**Colchester Avenue: Bikeways, Parking, and Intersection Safety Scoping Study
Public Meeting #2 Notes – Monday, January 11, 2021, 6:30 PM – 8:30 PM, Via Zoom**

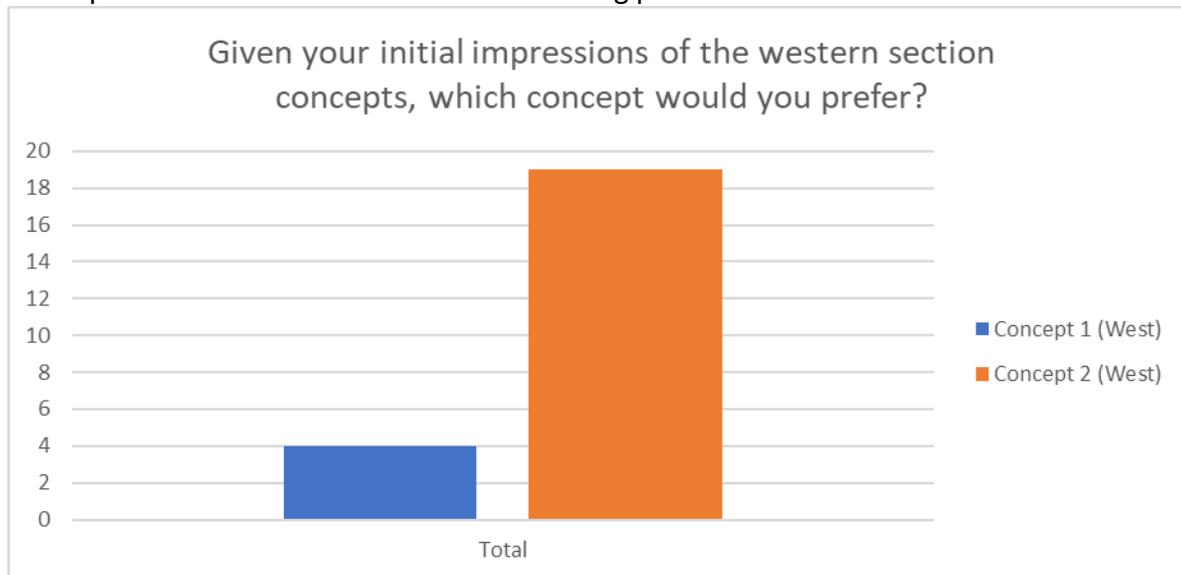
- Is stormwater runoff factored into the evaluation criteria? No. This will occur in the design phase.
- Why are there plantings in some sections and not others? The green belt is similar, but some areas are narrower due to right-of-way issues. In narrow areas, trees are not possible.

- How are bus stops accommodated with raised bike lanes? There are examples of how to do this and bus stops will be sited during the design phase.
- How do cyclists turn left with a separated raised path? Drew demonstrated the turn on Fletcher Place. There will be a slight shift in the separated lane where bicyclists could pull left, wait for a gap in traffic, and cross.

- Have you spoken to GMT? GMT actively participates in the Advisory Committee.
- Are raised bike lanes safer than on-street lanes? There is a perception that there is greater safety with a raised path versus an on-road, buffered, vertically delineated bike lane, and therefore more cyclists will use it. However, safety is about the same.

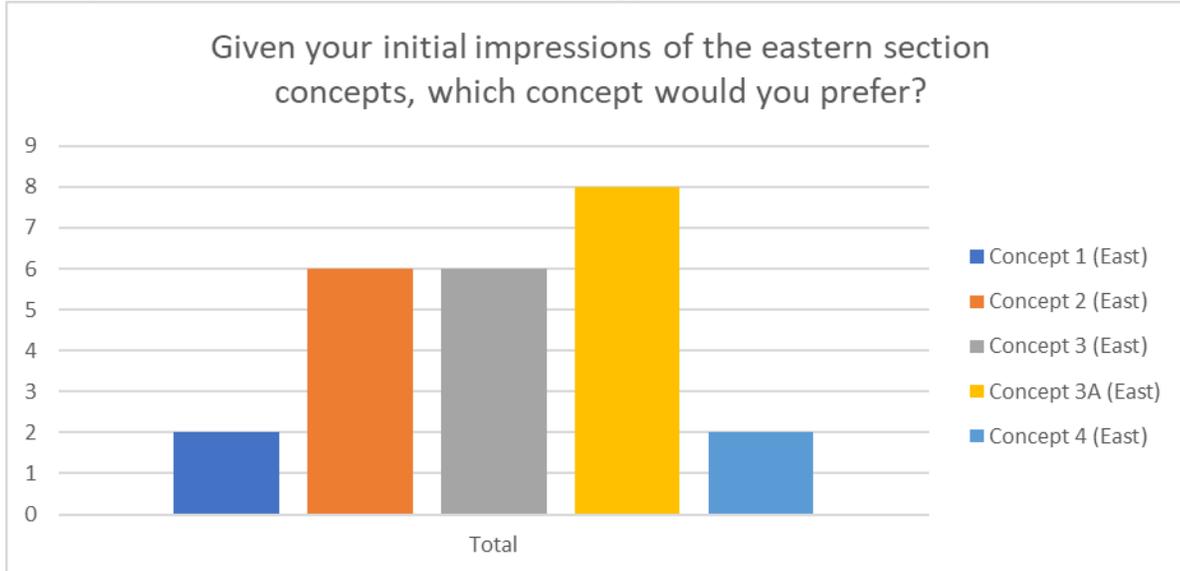
- What are the resulting right-of-way impacts (back of sidewalk change) for each alternative? All the concepts are within the existing right-of-way. The impacts beyond the existing back of sidewalk vary with location and would be determined more precisely in design.

- Which section has tree impacts? “Moderate” impact effects 4-6 trees. “Major” impact effects 10-11 trees. The preliminary design will be more detailed and better able to identify tree impacts with the help of the City Arborist.

- Where do bikes go in the “Mixing Zone?” Why can’t everyone be accommodated in the existing right-of-way? There isn’t enough frontage at Kampus Kitchen (with space also used for loading/unloading and parking) for separated paths. In the Mixing Zone, bikes and pedestrians share the path.

- Will people think the wide path is a two-way cycle-track? That is always a possibility, but it will be easy to navigate to other side of the street.
- Does the City have a plan for how to maintain the protected bike lane? Nicole Losch of DPW: We are developing a maintenance plan for protected bike lanes. Currently, we use the same sidewalk tractors for paths. We are looking at a new strategy to remove snow from bike lanes.

- Are “impacted” trees removed? We’re not certain at this point, the design phase will clarify this.
- Is there data about a Mixing Zone working for cyclists? It is a transition zone for a short section. Safety isn’t a major concern throughout the city for shared-use paths. The design phase would aim to minimize conflicts.

- Are there continuous bike lanes downhill for all alternatives? Yes.
- Can Alternatives 3A and 4 be combined? Yes. This can be further investigated.

- Why is the travel lane 12-feet in some places? Wider lanes are required when they are up against curb and these wider lanes are needed for emergency vehicles (to allow them to pass other vehicles).
- How do bikes enter/exit the separated lanes? At a driveway, street entrance or apron across from a street entrance.

Alternative 4 Roundabout

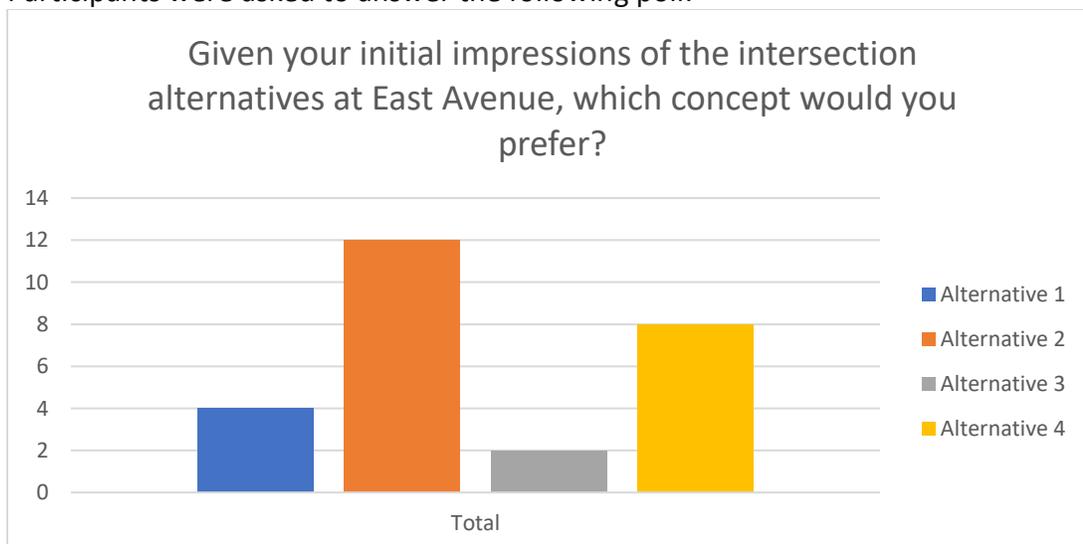
- What is the traffic performance of the roundabout versus a signalized intersection? The delay now is significant on East Avenue. Preliminary analysis shows that the roundabout would be an improvement in performance.

- How do cyclists who are heading westbound turn left to East Avenue? There would be 2-stage left turn box at the intersection.
- Can Alternative 1 work with separated raised bike lanes? No.

- Realignment alternatives would present impacts to Trinity Road at UVM and the EV charging stations.
- Is there an emergency vehicle issue with roundabout? This was assessed by evaluating emergency vehicles operating through the roundabout at 10 mph. Ambulances would not need to mount the apron at this speed, making this design reasonable given the proximity to the hospital.

- How do cyclists enter and exit the roundabout? Drew used a diagram to explain this movement for the eastbound cyclist. In this case they would be in the bike facility, navigate around the edge of the roundabout to the crossing set back on the East Avenue approach, cross one direction of traffic at a time, and then navigate around the edge of the roundabout on the east side to continue on Colchester Ave.

- Is a roundabout safer than a signalized intersection? Roundabouts have more continuous free-flowing traffic than a signal, but by design they slow down vehicles at the approaches. Other treatments on the road may also slow traffic.

- Can a cyclist navigate the roundabout in the roadway itself? Yes, if they choose to.
